Annex H

Heworth Ward

H1

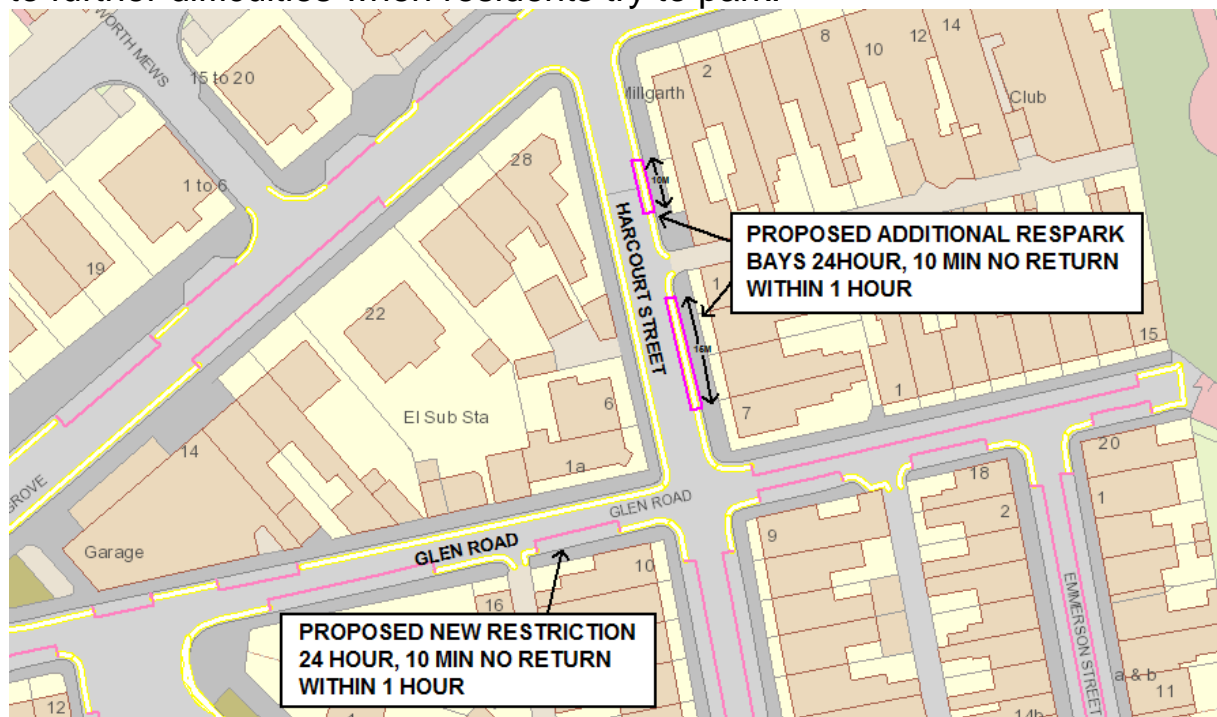
- The reason for our objection is that our garage is situated in a lane off Harcourt Street alongside no. 6 Harcourt Street, and we have difficulty entering the lane even before anything is changed, particularly when larger vehicles or vans park opposite the lane end, even though there are double yellow lines. Sometimes we have to ask drivers to move their vehicles along so that we have access to our lane.

Owing to the tightness of the two brick walls on either side of our lane, neither of which are our property, we experience difficulty in entering the lane. We need to position our car as near to the

opposite side of the road as possible, straighten the car to miss the two brick walls, and pull in the wing mirrors prior to entering the lane.

We notice that there is a similar lane to ours on the opposite side of Harcourt Street a few metres away and that this will not have any car parking spaces directly opposite to it under the proposals. We were surprised that we did not receive a letter from the Council about these changes, despite the fact that our property has a right of access to and from Harcourt Street. Also, on the map accompanying the Council letter, our lane is not clearly marked.

We would like to express our concerns and suggestions in relation to the proposed parking arrangements detailed in paragraph 2(i) of the Amendment Order, namely the alterations proposed on the east side of Harcourt Street between the northern boundary line of No. 7 and a point 15m north of that boundary.

We do not object to the principle of some parking spaces in the delineated area, particularly close to the properties at No. 1 and 3 as these properties are furthest away from the parking on Glen Road. However, we are aware that some residents of Hawthorn Grove are concerned about the impact of parking in this location on their ability to reverse into and out of their garage and I understand that they have contacted you separately about this. Residents of Nos. 5, 6 and 7 object to parking outside No. 5 due to the increased noise and disturbance from parked cars in close proximity to the front of our houses.

In addition, we are all concerned about the visual impact of parking on the street as it would mean that we are looking out on parked cars and are faced with them on coming out of our front doors. We consider that having a row of parked cars along the street will create a poor visual environment and will do nothing to enhance the attractiveness of the street. You will be aware of the

As residents we are of the view that any parking spaces provided in this part of Harcourt Street should incorporate a wider consideration of the street environment, traffic calming and how this can be improved. To this end we would ask the Council to consider the following measures on this part of Harcourt Street: Narrowing the street to provide traffic calming; Incorporating planters with street trees / vegetation to make the environment more attractive and to separate parking spaces.

Consider the potential for closing this part of the road to all but traffic for residents effectively creating a Home Zone, the likes of which was considered some years ago;

Alternatively, making this part of Harcourt Street one way, which would have the effect of reducing through traffic to an extent.

It is also worth noting that many years ago there were parking spaces outside 1A Glen Road and it may be possible to reinstate these thus reducing the number of spaces needed on Harcourt Street.

The additional parking bays on Harcourt Street should not affect the ability of residents to enter the lane. Some of the recommendations received from residents are outside the scope of this review. The recommendation is to implement as advertised with a view to monitor and consider further highway improvements in the future.

H2

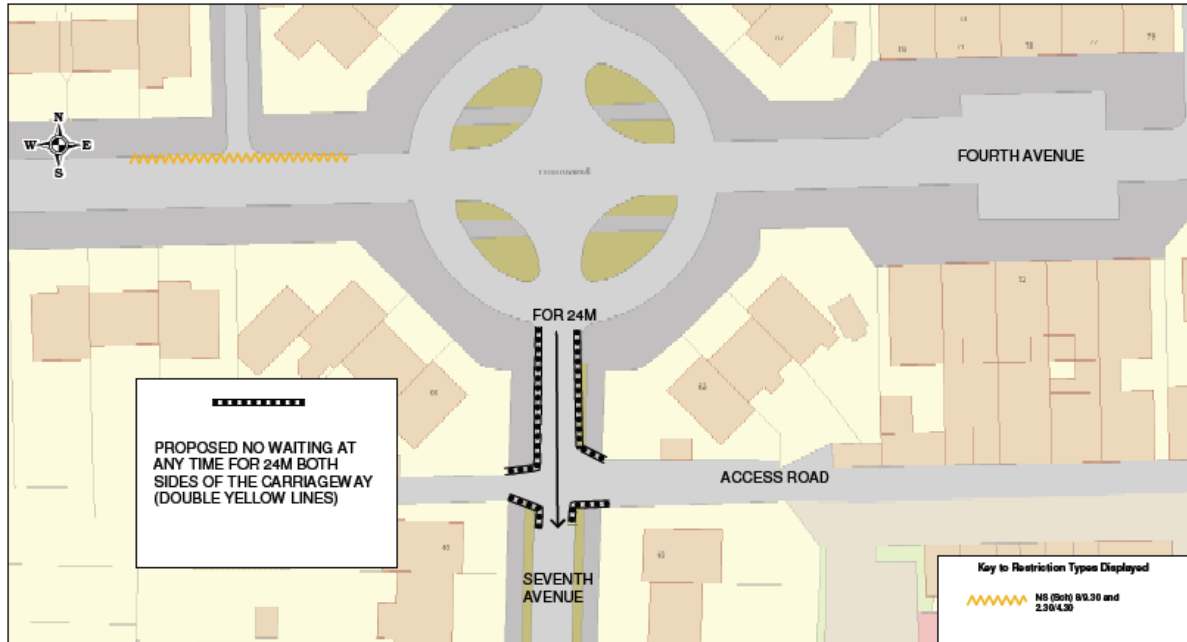
- Where are we meant to park our cars after these lines go down???? We have no drive and can't afford to put one in ourselves. With the other yellow lines on the junction proposed then they will need some where to park to, and on our side our house is the usual spot. Unless we can have a drive provided or allocated parking for two cars outside our house. It going to be a problem.

- I'm all for restricted parking Monkton Road to allow busses easier passage. Would like ban on grass verge parking churning up all the grass and leaving a muddy eye sore

The length of the restrictions advertised are the length of 20m to protect pedestrian visibility when at the pedestrian crossing points on Monkton Road and Elmfield Avenue. Therefore the recommendation is to implement as advertised.
